Proposal for Supplement 7 to the 01 series of Regulation No. 112

1. This revision 1 of GRE-76-04 introduces a reference in paragraph 6.2.9. to “zones a), and b), as specified in the table below” and amends figure b) of annex 3.
2. If adopted, this proposal will update the proposal for amendments to Regulation 112 presented in ECE-TRANS-WP29-GRE-2016-34e.

“Figure B

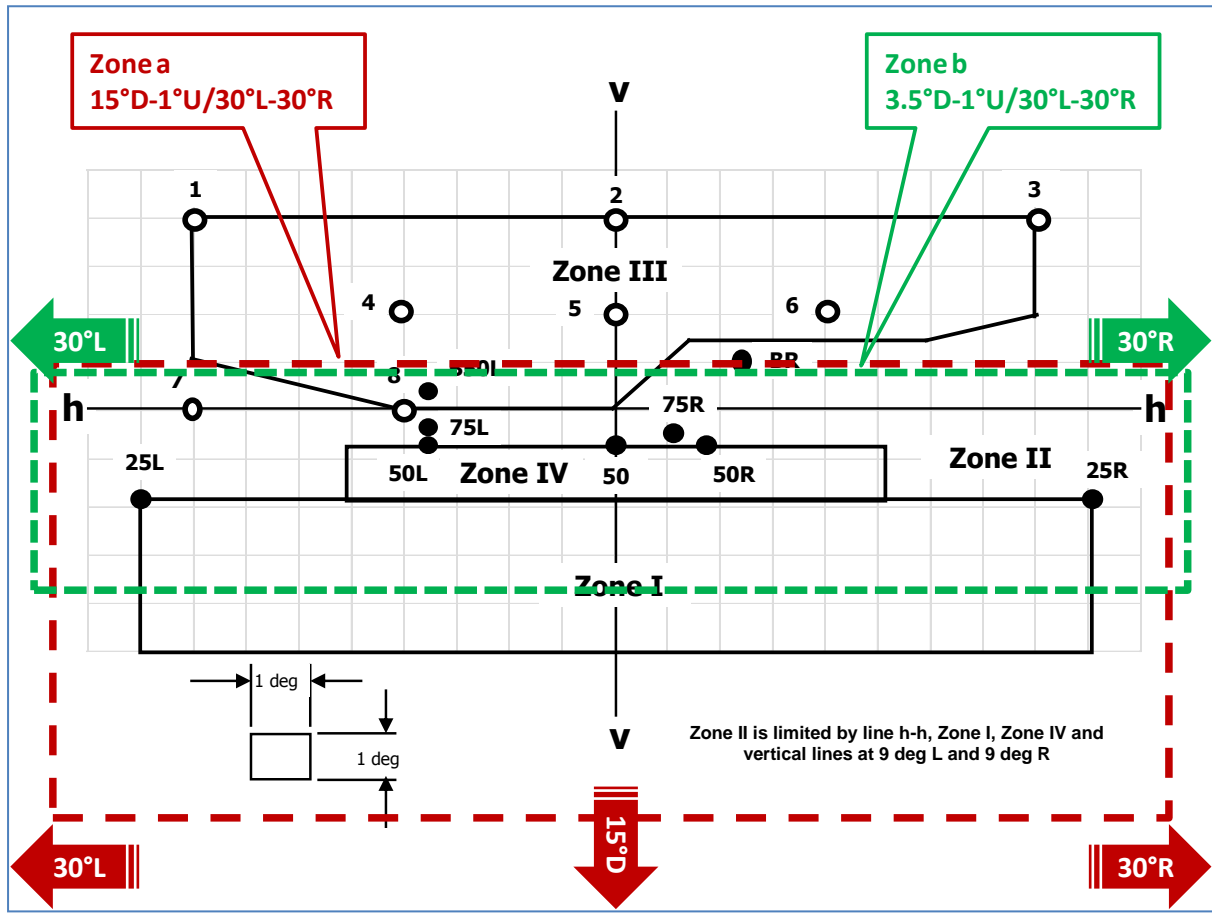
Annex 3, replace the existing figure b) to read:

Passing-beam for right-hand traffic

h-h = horizontal plane , v-v = vertical plane passing through the optical axis of the headlamp

The test point locations for left-hand traffic are mirrored about the VV line”

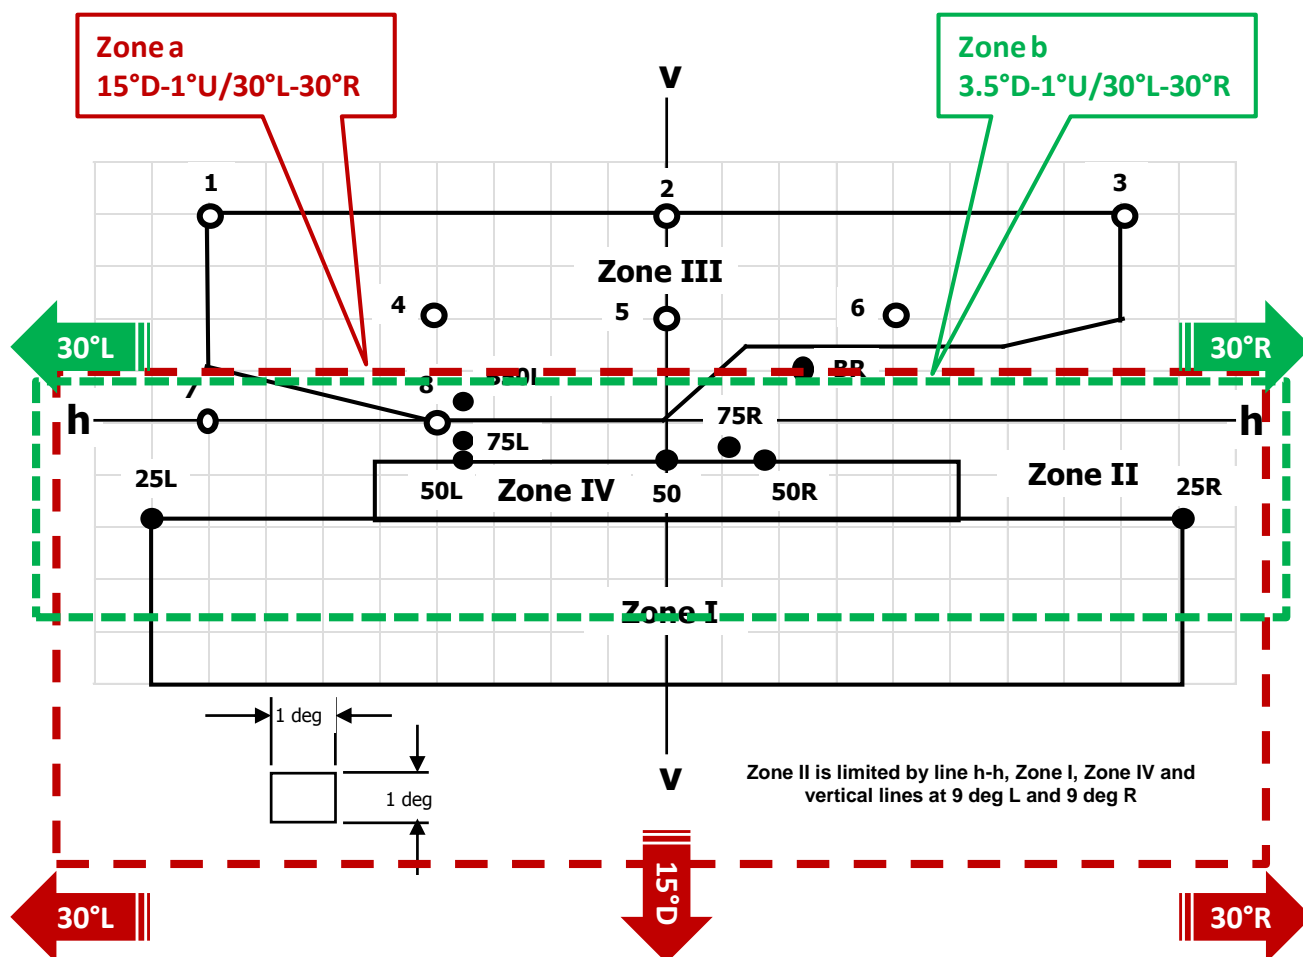
5. With the experience of producing many millions of LED headlamps it is clear that passing beams can be designed to use LEDs having an objective luminous flux of less than 1,000 Lm. These can provide an inexpensive solution for energy saving vehicles (e.g. the electrical

urban vehicles), while giving at least the same luminous intensity as other light sources. However, at previous sessions of GRE, some experts pointed out that this modification could lead to headlamps producing marginal performance despite the fact that they achieve the current photometric requirements of the Regulation. The current prescriptions of Regulation No. 112 in combination with approved filament light sources producing a minimum objective flux of 800 lm (H8) ensures that the passing beam produces a satisfactory level of illumination of the road

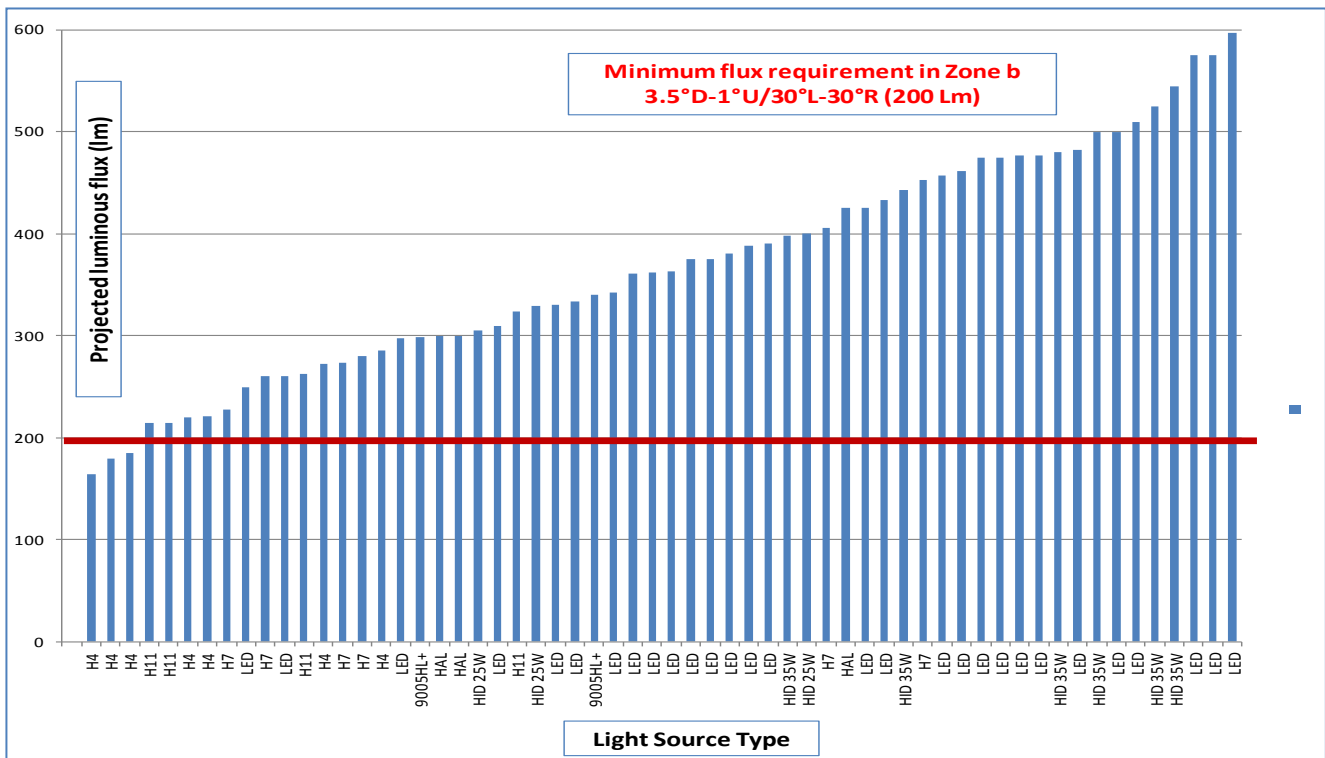
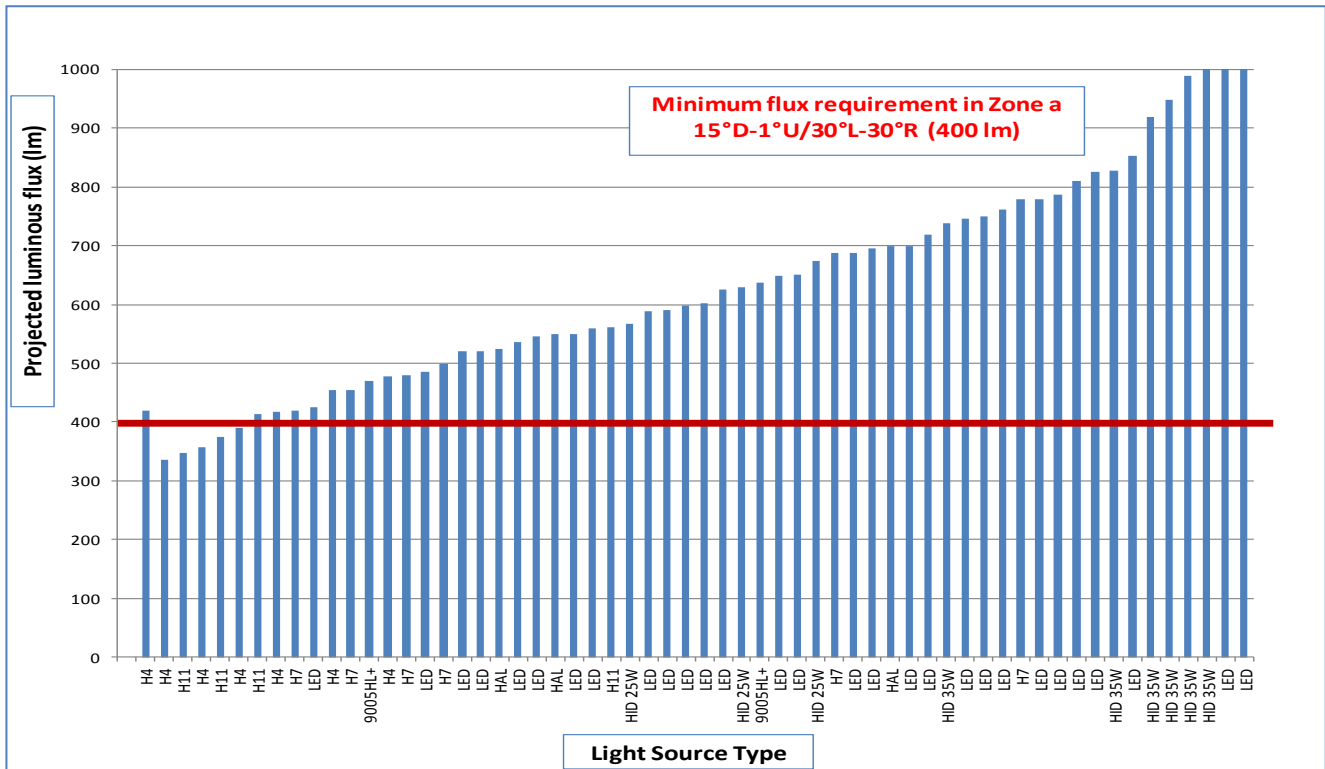
7. The result of the GTB study is to propose minimum projected flux requirements in two zones:

- a) $15^{\circ}\text{D}-1^{\circ}\text{U}/30^{\circ}\text{L}-30^{\circ}\text{R}$ to ensure overall adequate illumination of the road and
- b) $3.5^{\circ}\text{D}-1^{\circ}\text{U}/30^{\circ}\text{L}-30^{\circ}\text{R}$ to ensure sufficient range.

These zones are shown superimposed on the figure B of Annex 3 in the diagram below.

These two zones have been chosen as a compromise between ensuring a safe minimum level of performance and the need to find a solution that does not invalidate any headlamp technologies type approved according to the current regulation

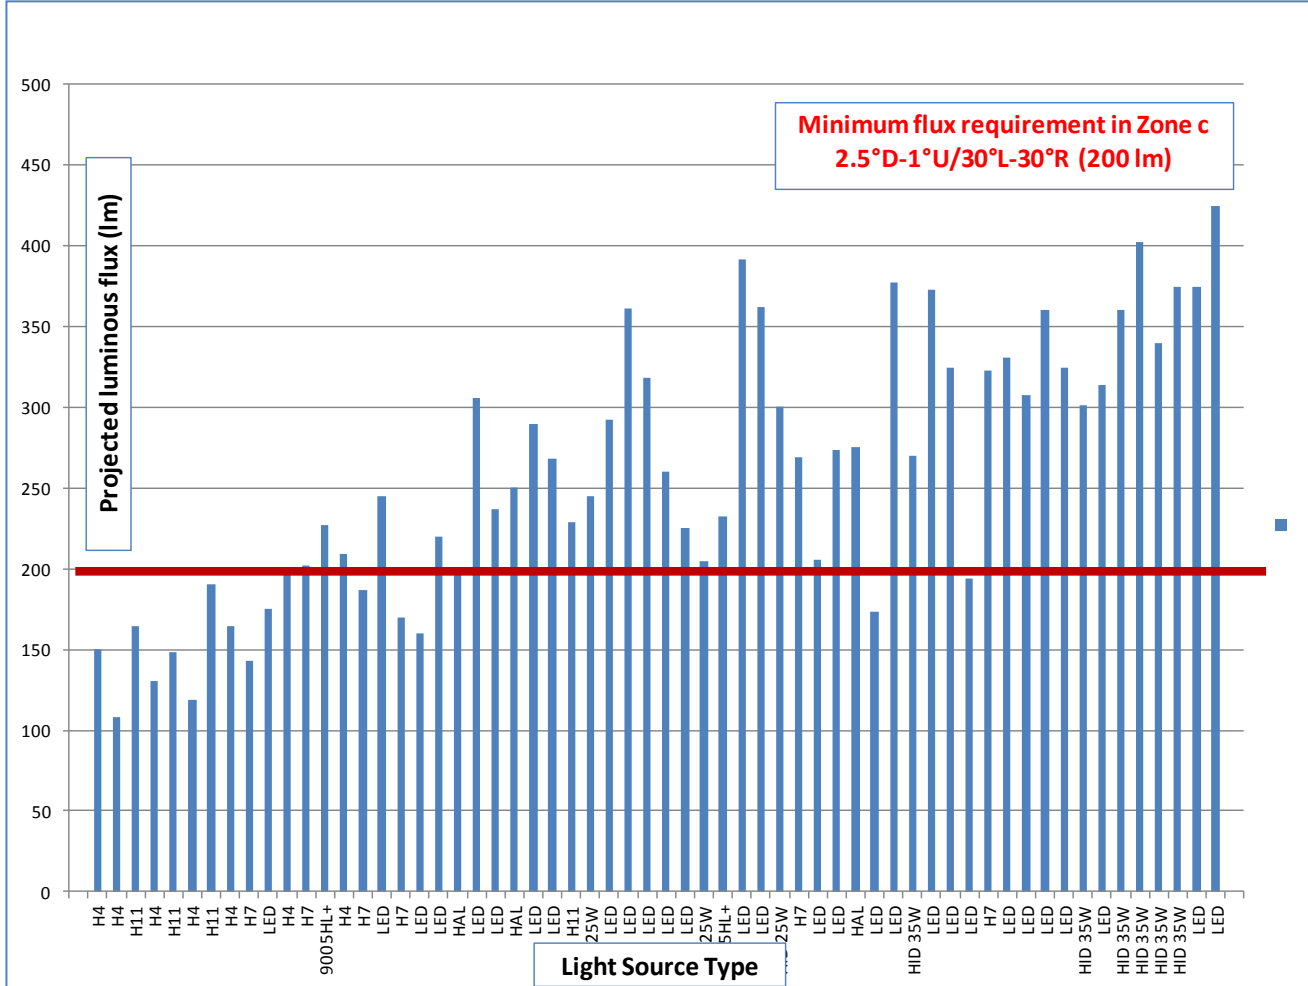
8. A range of 60 passing beam headlamps equipped with various light sources, all in production and type approved to the provisions of Regulation No. 112, was measured to determine the actual flux projected into the zones a) and b) with the following result:

It can be seen that a small percentage of the passing beams tested will not comply with the 400 lm and 200 lm requirements but the GTB experts concluded that this would not present problems for manufacturers.

These results show that whilst all the LED passing beams meet the 1000 lm objective flux requirement this criterion has no significant influence upon the actual photometric performance of the headlamp. This design specific requirement in the context of current LED headlamps should therefore not be perpetuated.

- The minimum projected flux requirements in Zones a and b can be adopted as a technology neutral, performance based, requirement that will assure that the current performance levels achieved by type approved headlamps with filament light sources can be also assured with LED sources.
